NEW MEXICO ENVIRONMENT DEPARTMENT

Re: Chevron Mining, Inc. (CMI), Questa Mine; Major Individual Permit; SIC 1061; NPDES Compliance Evaluation Inspection (CEI); NM0022306; July 24 thru July 26, 2018

NPDES Compliance Inspection Report

Chevron Mining Inc. - Questa Mine NPDES Permit No. NM0022306 Compliance Evaluation Inspection July 24 thru 26, 2018

NMED/SWQB
Official Photograph Log
Photo # 2

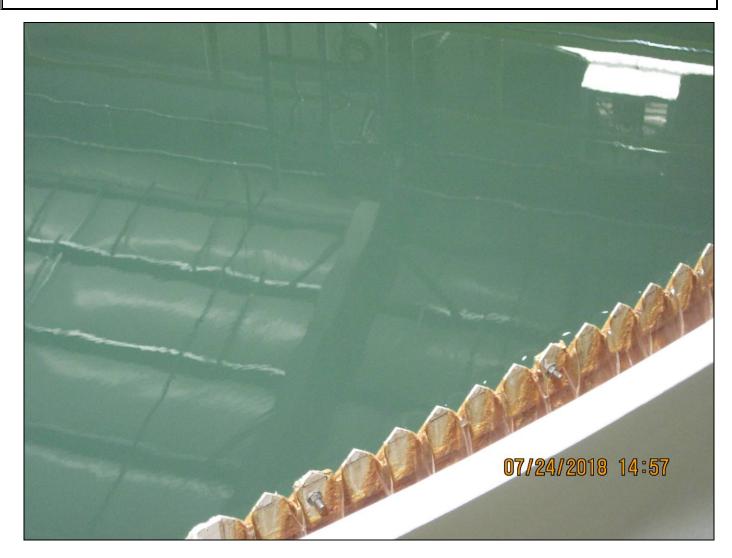
1. TREATMENT UNITS PROPERLY OPERATED.	⊠s □ m □ u □ na
2. TREATMENT UNITS PROPERLY MAINTAINED. See Photo Documentation for WTP Clarifier Weir	\square S \boxtimes M \square U \square NA

NMED/SWQB Official Photograph Log Photo # 6

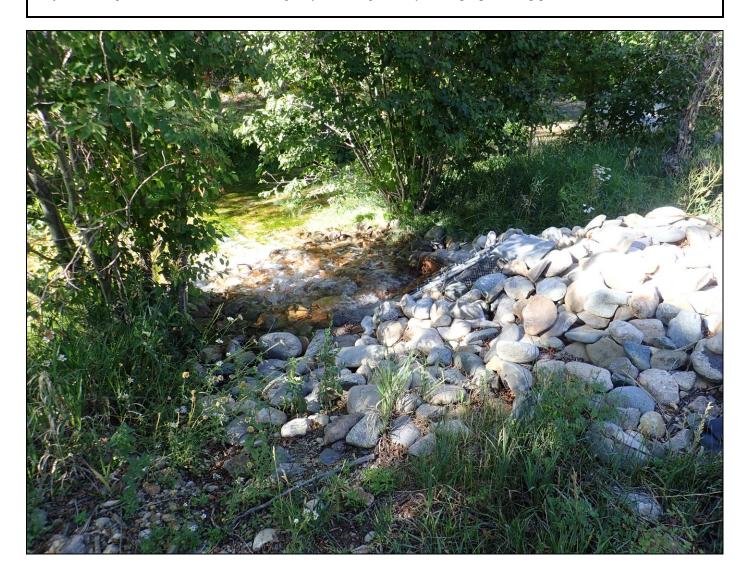
Subject: Looking south toward Red River from highway NM 38 right of way, rock rip rap, culvert pipe outlet and flow at Outfall 001.
